Title of Change:	Revision of Case Outline 506AX.
Effective date:	25 Aug 2020
Contact information:	Contact your local ON Semiconductor Sales Office or IgnatiusPillay.FelixAmbrose@onsemi.com
Type of notification:	This Product Bulletin is for notification purposes only. ON Semiconductor will proceed with implementation of this change upon publication of this Product Bulletin.
Change Category:	New revision of Case Outline 506AX
Change Sub-Category(s):	Datasheet/Product Doc change

MECHANICAL CASE OUTLINE
PACKAGE DIMENSIONS

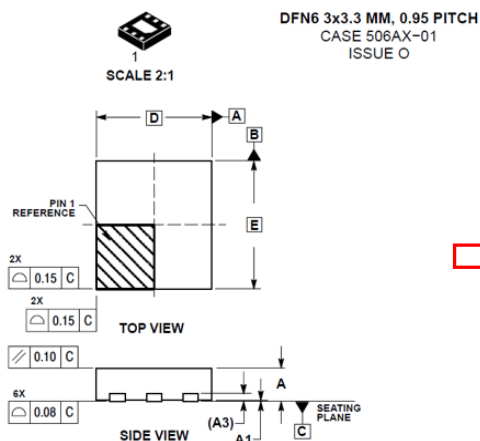
To change the A dimension, package thickness from 0.80mm to 0.90mm to 0.80mm to 1.00mm for case 506AX.
No change to solder footprint is required. There is no material or manufacturing change; this is a document update only to align to standards and manufacturing capability

CHANGE A DIMENSION MAX LIMIT TO 1.00MM INLINE WITH JEDEC SPEC
